5th and Virginia

SECTION 02. DRB REC1 GUIDANCE AND DESIGN RESPONSE

SECTION 02. DRB REC1 GUIDANCE & DESIGN RESPONSE

Details of Level 12 tower lighting (Reveal) at the amenities level indicating lighting effects tailored to Board guidance.

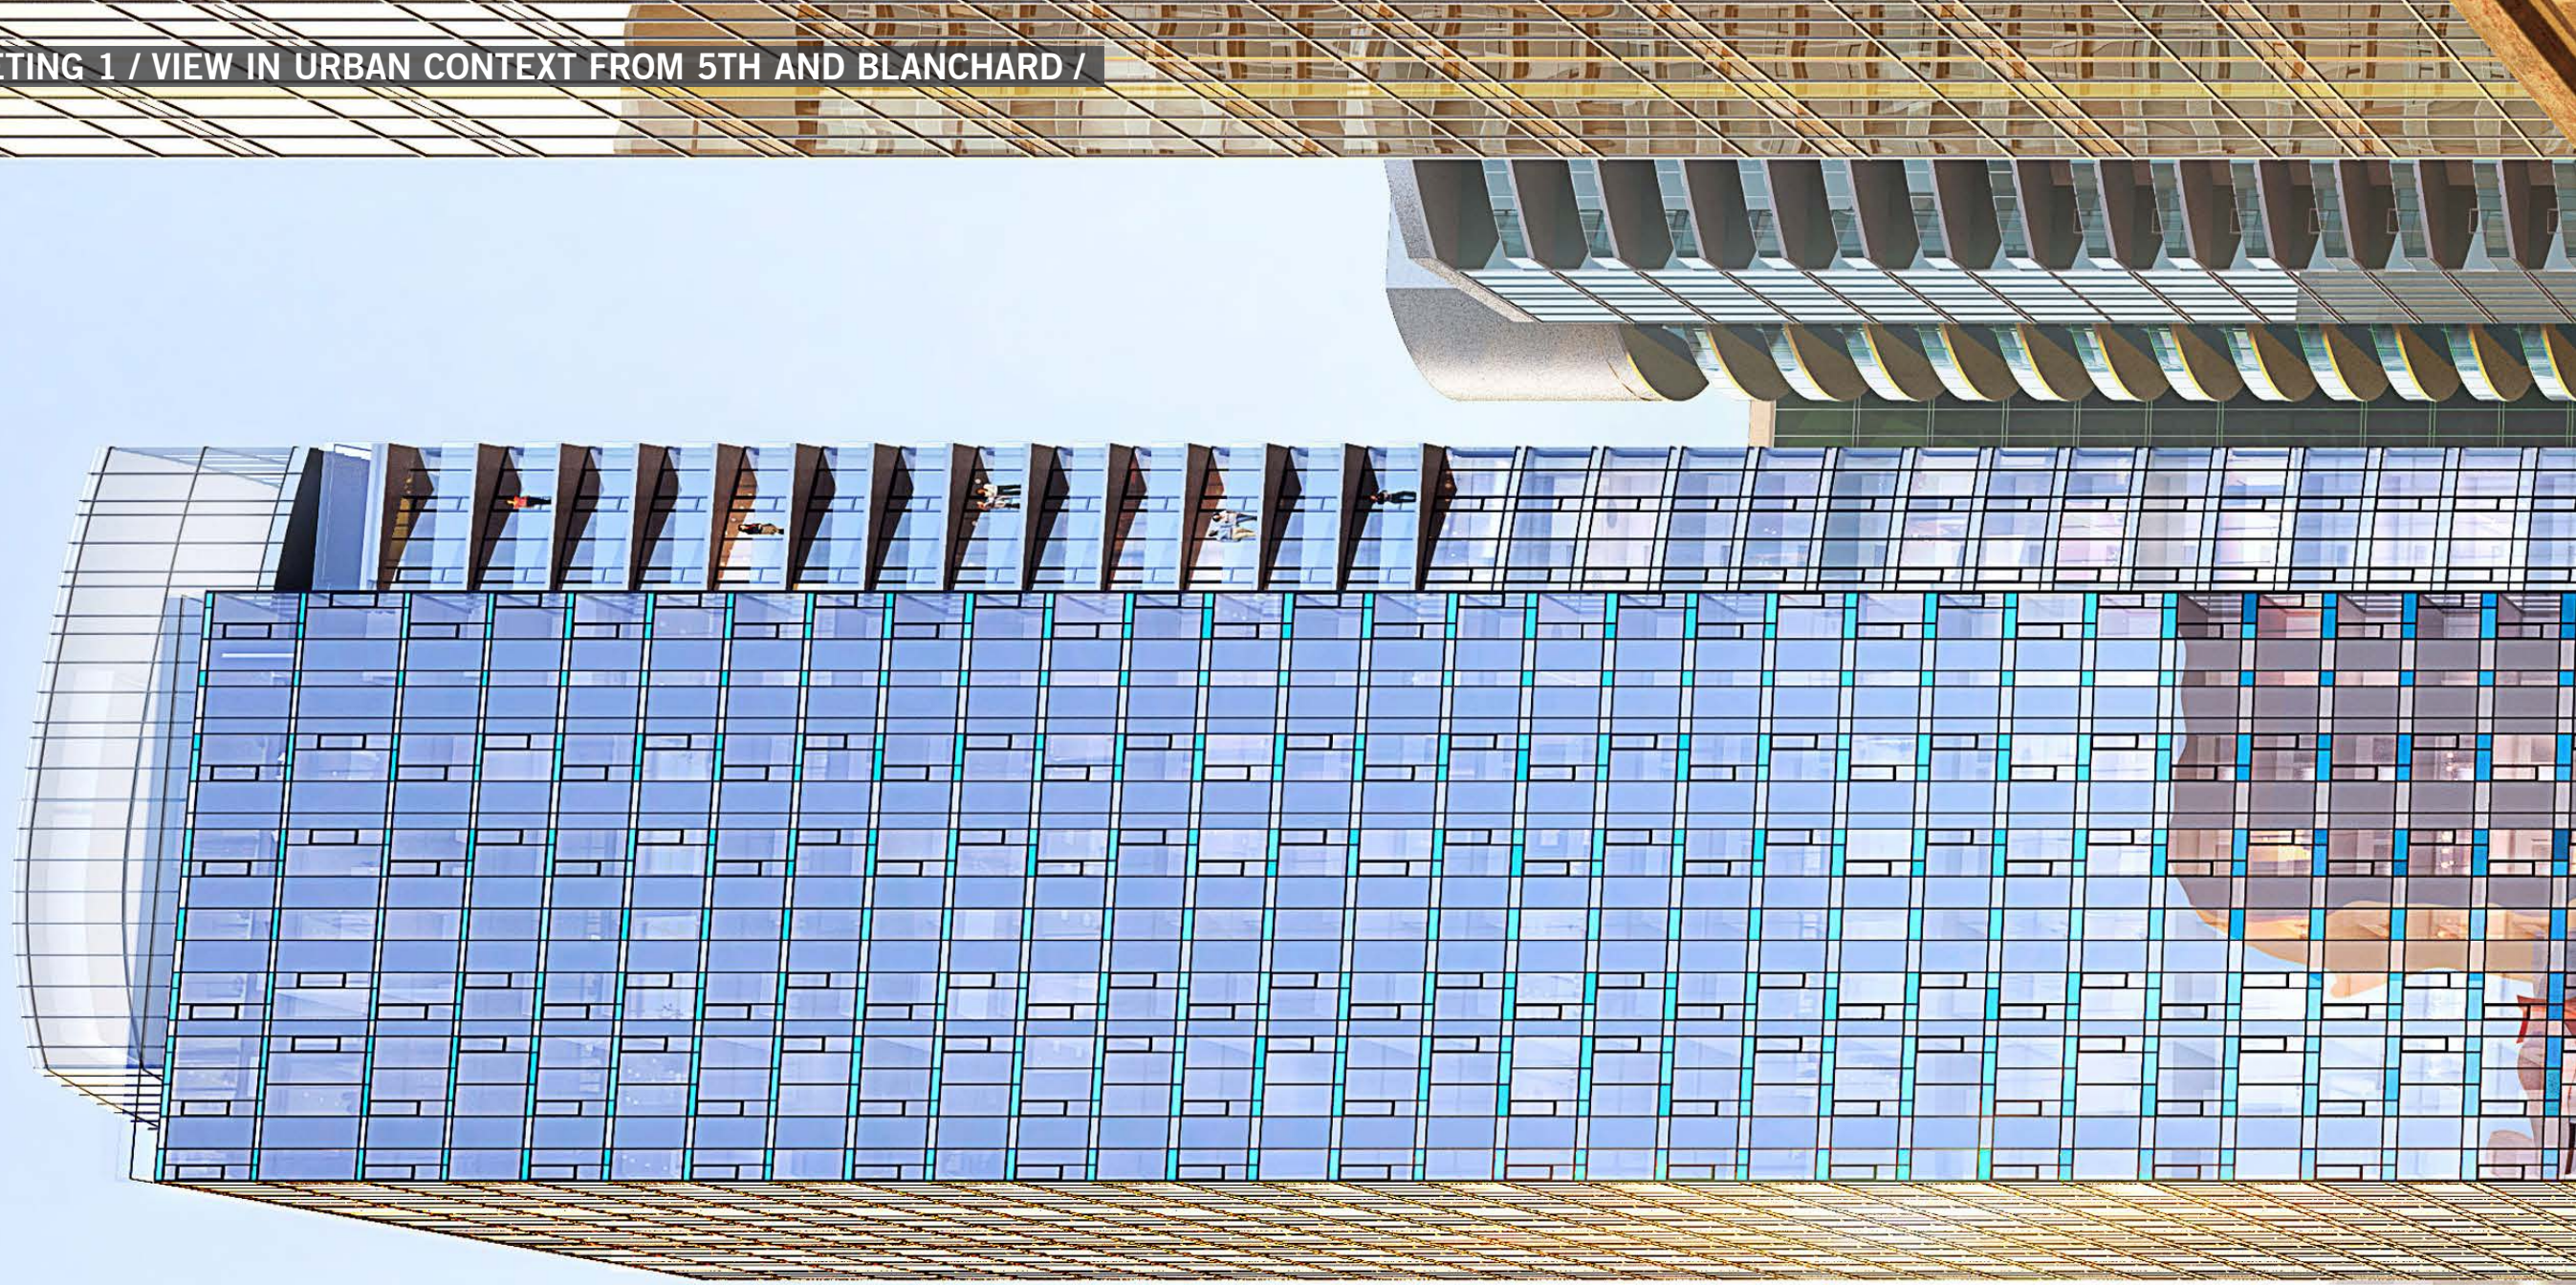
The Board reiterated the importance of the tower top lantern having sufficient glow and presence at dusk and dark night conditions [the image on pg 125 was minimally acceptable pertaining to amount of glow/presence]. The Board recommended more details on that element be provided to staff and at the next meeting, including large scale sections with fixtures shown, reflected ceiling plans, and specific fixture cut-sheets. The Board supported the stated intent to up-light the important soffit at the level 12 recess. (D5, A2)

The top lantern design has been developed in accordance with Board guidance, and requested details are provided in subsequent pages of the submittal.

West Elevation Tower Levels 13 - 46

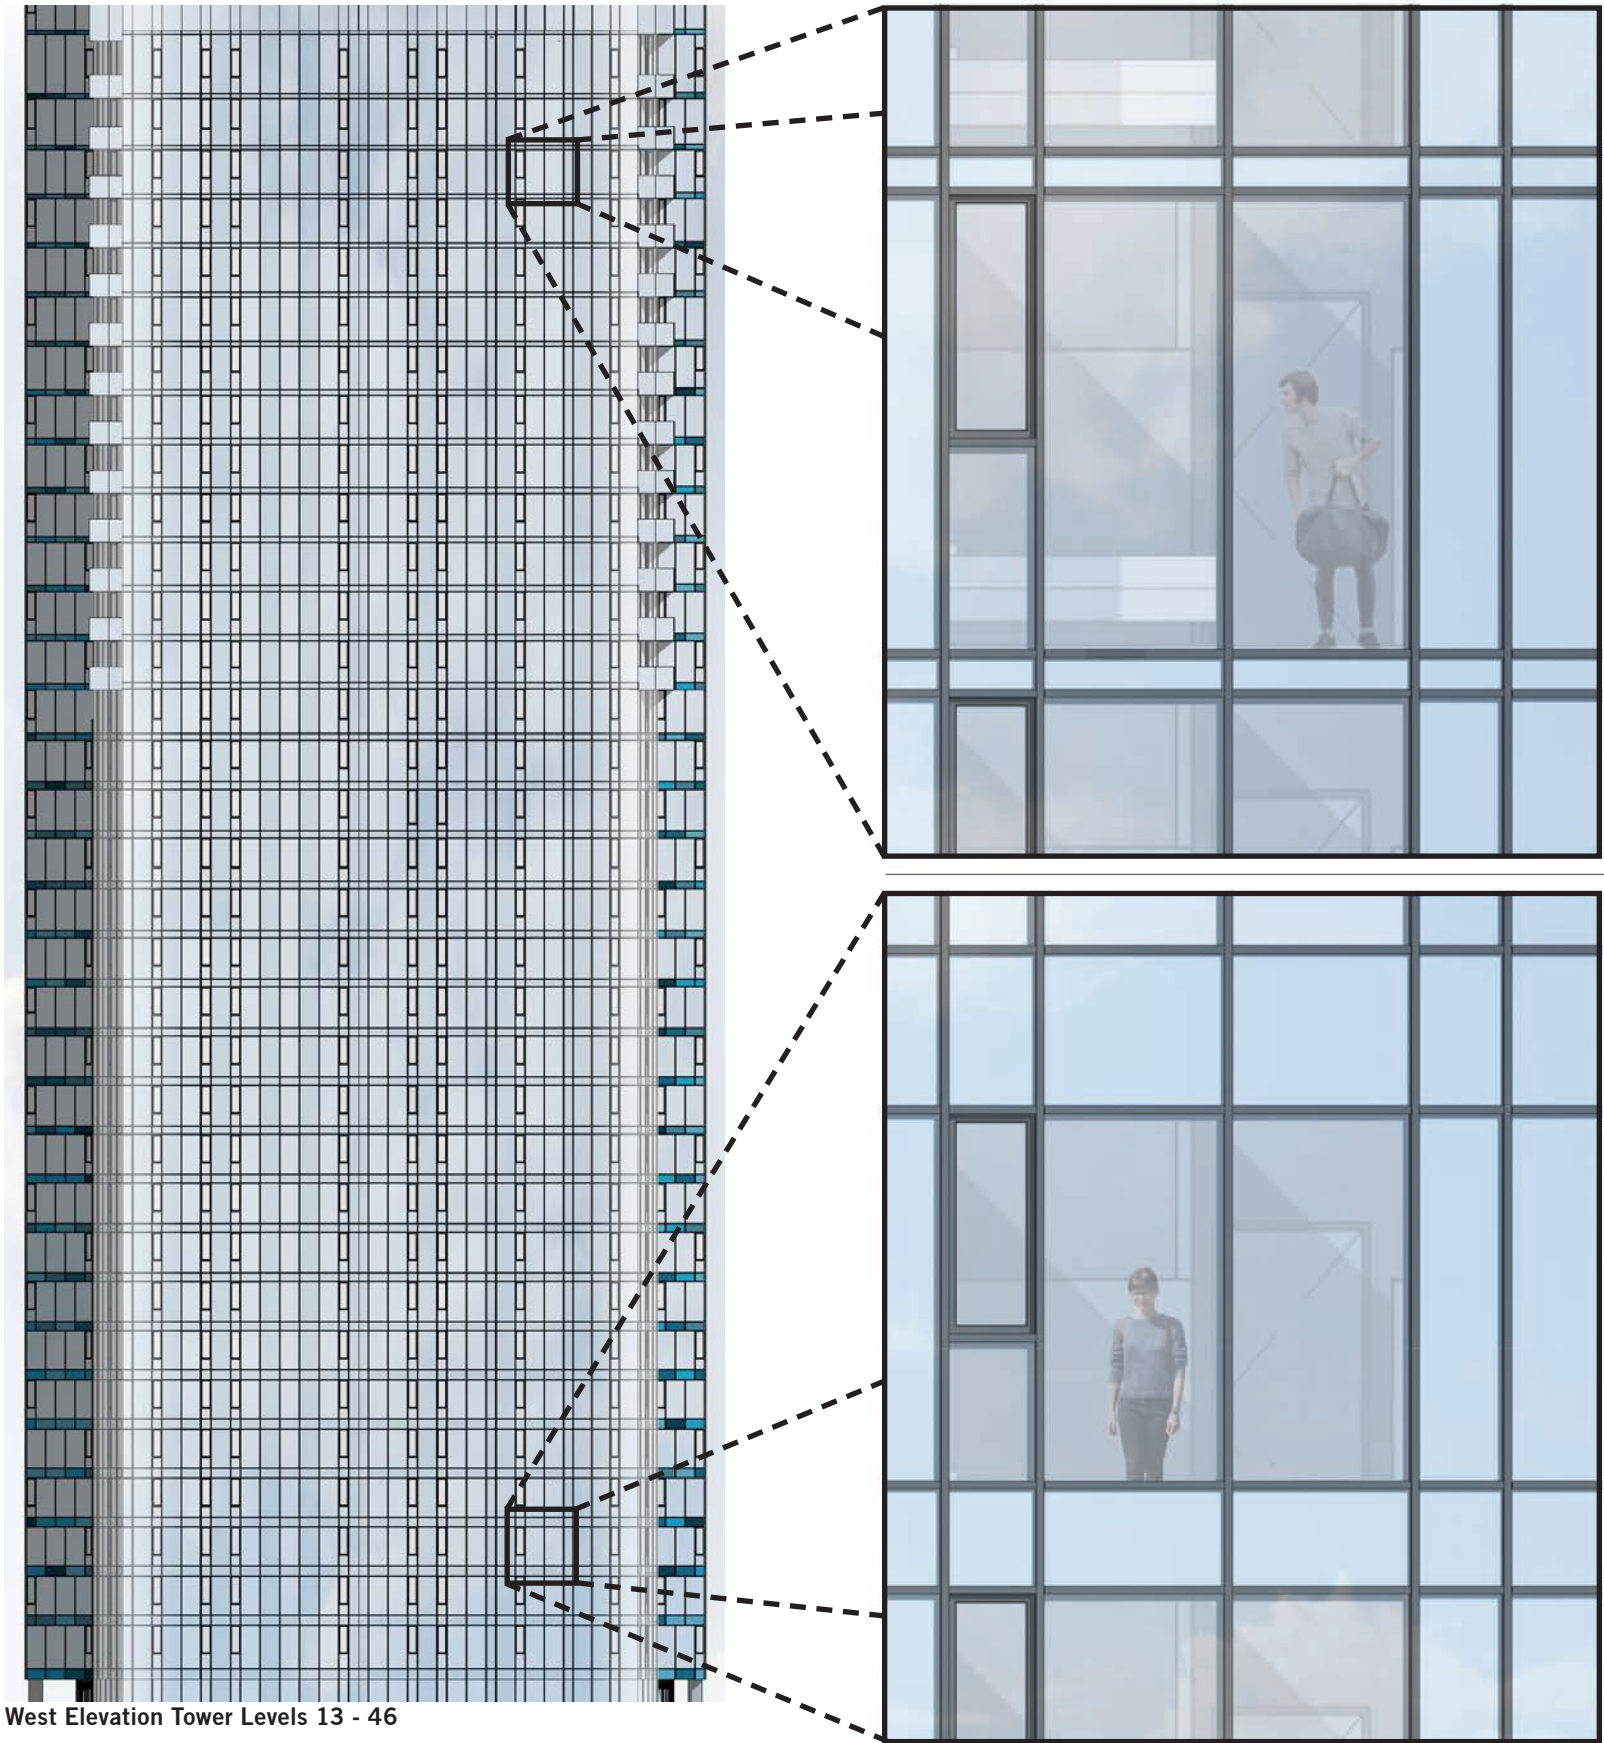
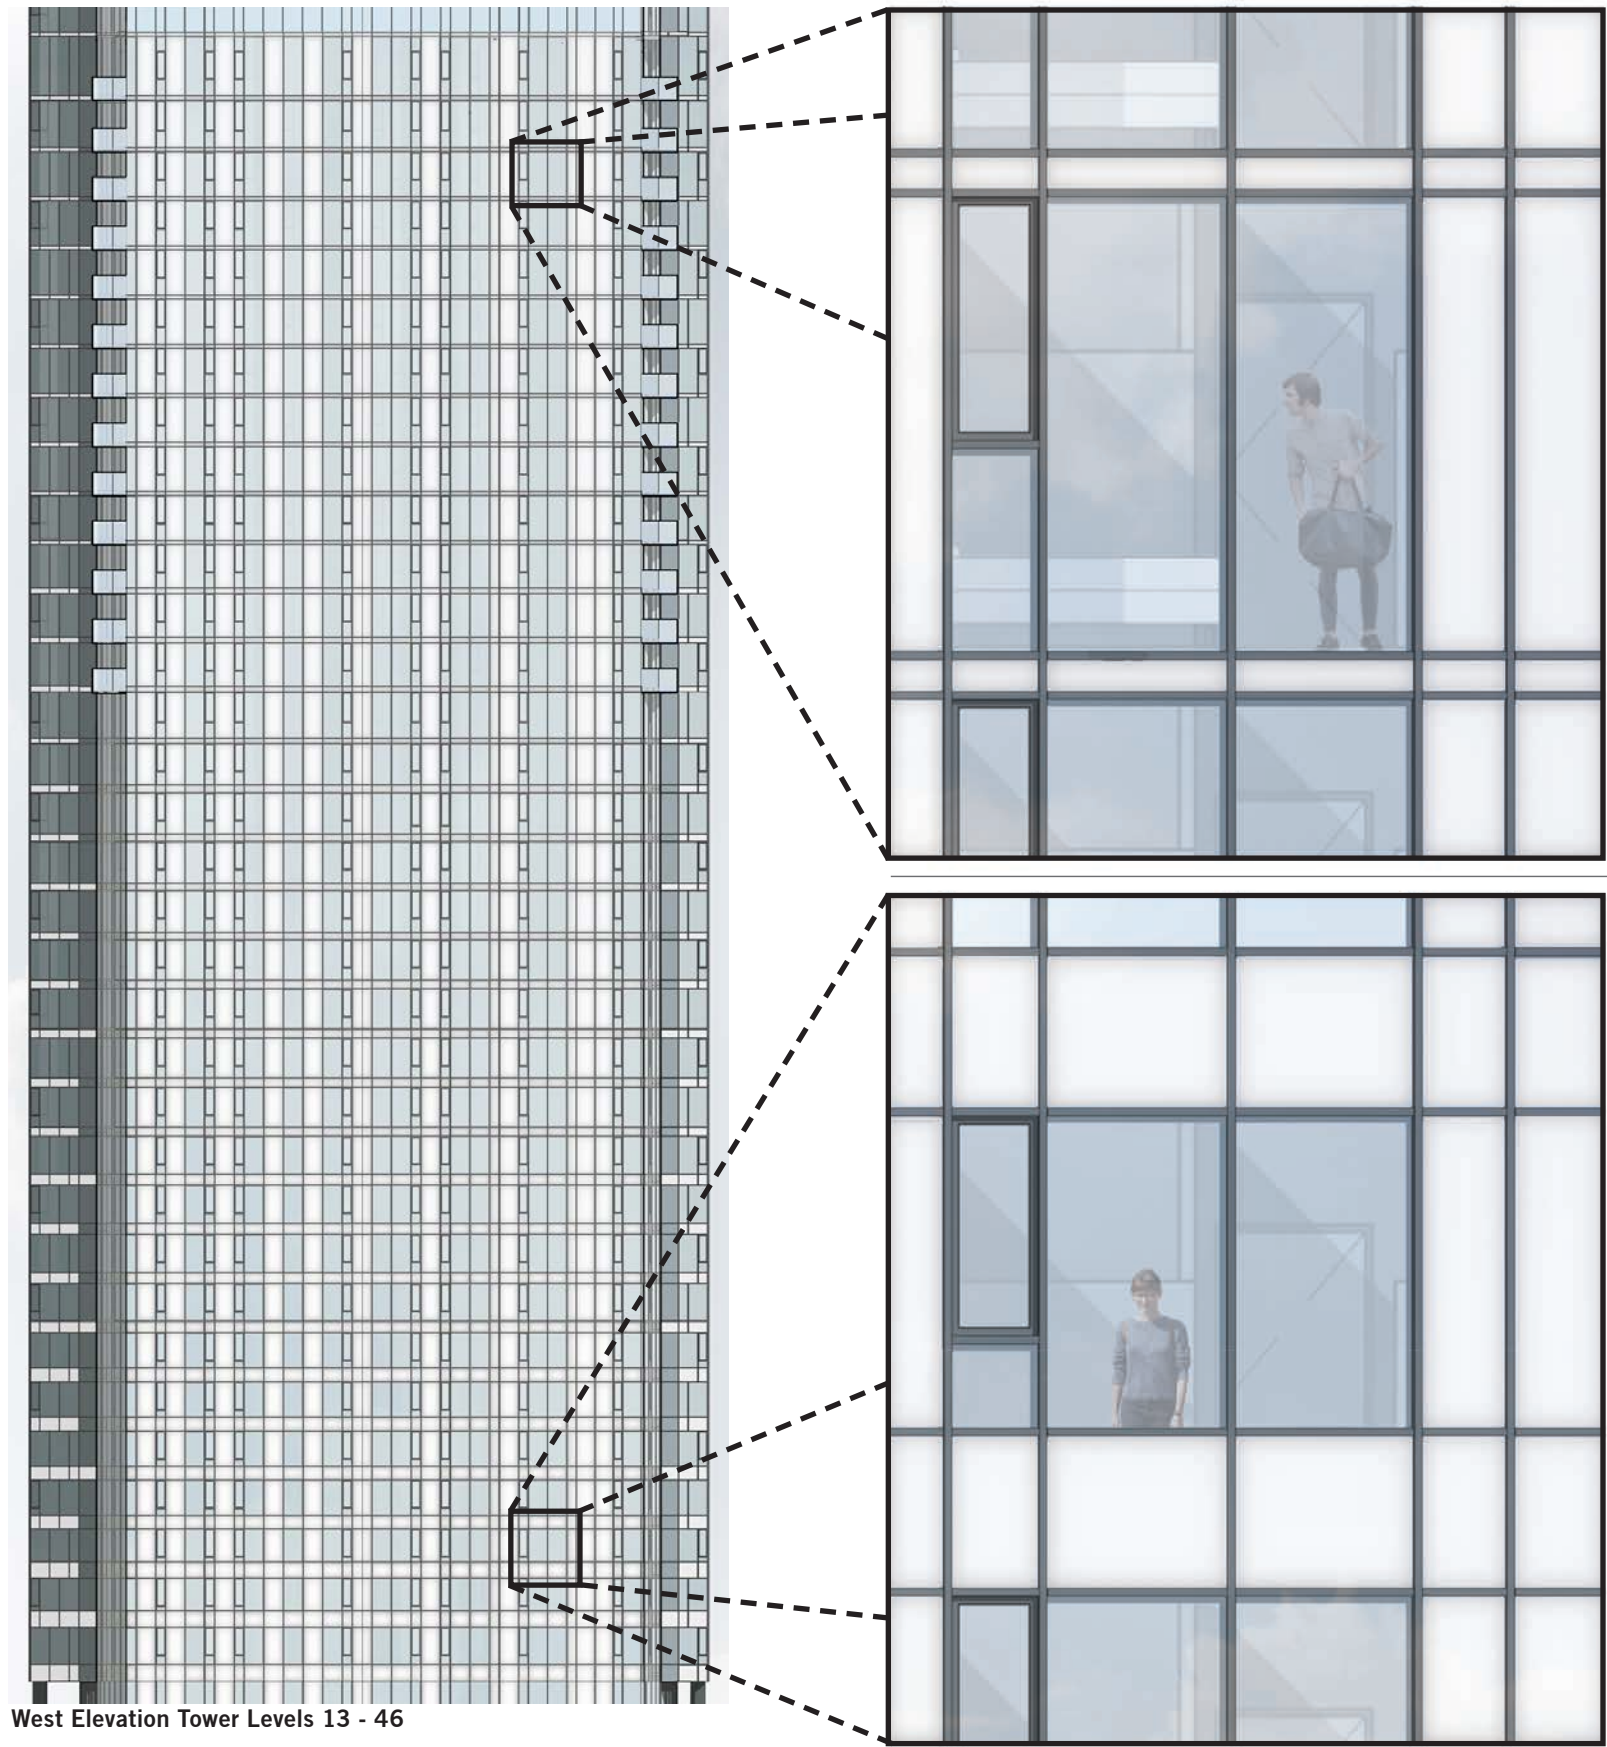
The amount of opaque area on the western mass has been increased as shown at each step of the design review process, thereby reducing the amount of vision glass as shown.

To measure impacts of vision glass area reduction we have indicated the vision glass areas as a percentage of overall exterior area (for REC1 and REC2), and also indicated the net reduction in vision glass area as a percentage of vision glass area from REC1 to REC2. Note that the REC1 vision glass area was already significantly reduced from EDG2 and that the vision glass % opposite Escala is significantly less than the vision glass % of Escala – the proposed development has less than 1/2 the vision glass % of Escala at the hotel, and approximately 2/3 the vision glass % of Escala at the residential apartments.

The amount of vision glass on the western façade has been greatly reduced, and the gradient dimension of the spandrels has been emphasized by the enlargement of the spandrels and the redistribution of the diminishing dimensions of the sills across the remaining floors.
